IMPORTANT SAFETY RECALL

NHTSA Recall # 26V-156

Tiffin Recall # TIF-147

Incorrect Cargo Carrying Capacity Label

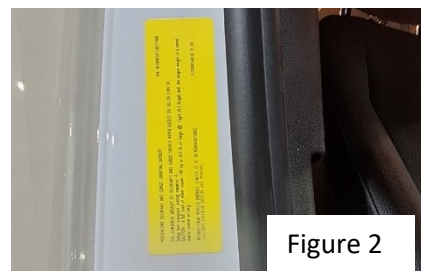
Certain motorhomes do not have the correct safety belt equipped seating capacity listed on the Occupied Cargo Carrying Capacity label, which can lead to additional passengers in the motorhome that are not secured by a seatbelt. Passengers in a motorhome that are not secured by a seatbelt can lead to injury.

1. The yellow Cargo Carrying Capacity Label can be found on the passenger's side door panel Figure 1.
2. Remove the old label and discard.
3. Clean the passenger's side door jamb with isopropyl alcohol and place the new label as shown in Figure 2.

Tiffin Motorhomes will replace the incorrect label with a label that correctly states the safety belt equipped seating capacity listed.

To correct this issue, we are sending owners a corrected Occupied Cargo Carrying Capacity Label to be placed in your motorhome (enclosed).
